PROJECT TITLE: Bell Apartments ZONE ATLAS/DRNG. FILE #: E11/347 ^{P24}
LEGAL DESCRIPTION: Lot 11, Block 1, Volcano Cliffs Subdivision, Unit 3
CITY ADDRESS: Don't have.

RE: REVISED DRAINAGE PLAN FOR BELL APARTMENTS
(E-11/DN) REVISION DATED DECEMBER 23, 1988
024

DRAINAGE PLAN

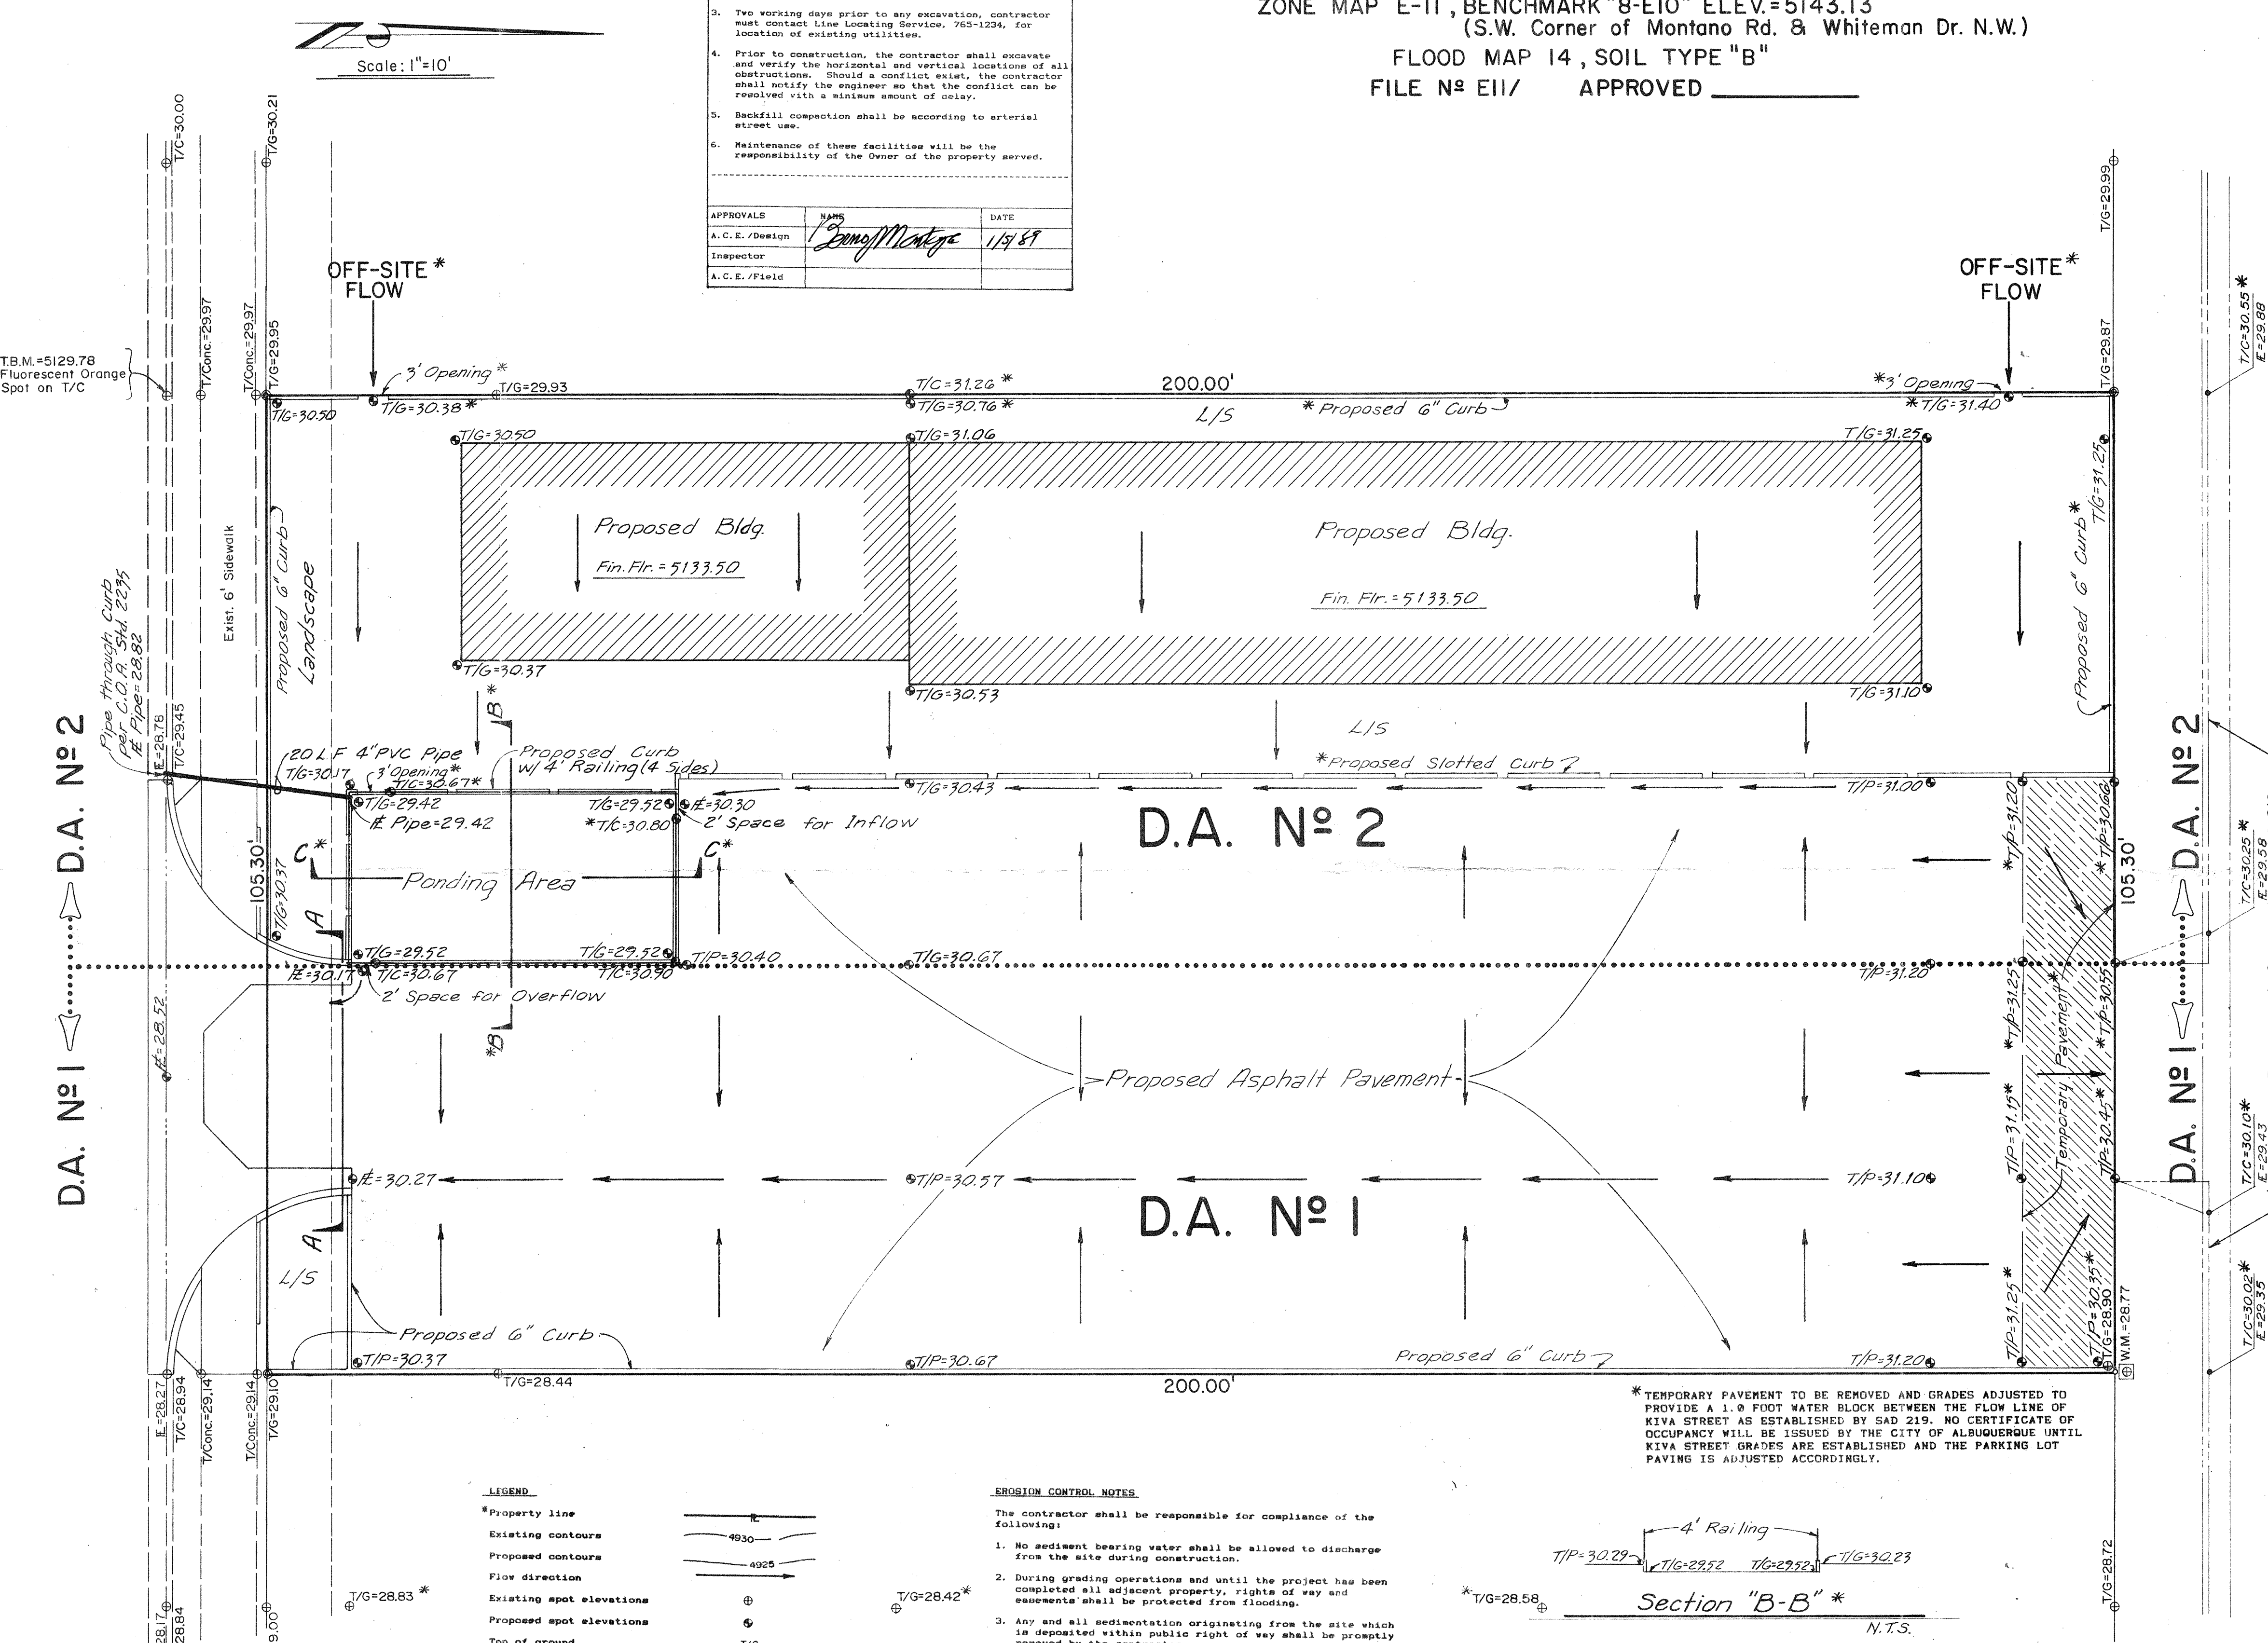
Based on the information provided on your resubmittal of December 28, 1988, the above referenced plan is approved for Building Permit.

Also, the permanent Certificate of Occupancy will not be released until the street grades on Kiva Street are established and the parking lot paving adjacent to Kiva Street are adjusted accordingly.

Please attach a copy of this plan to the construction sets prior to sign-off by Hydrology.
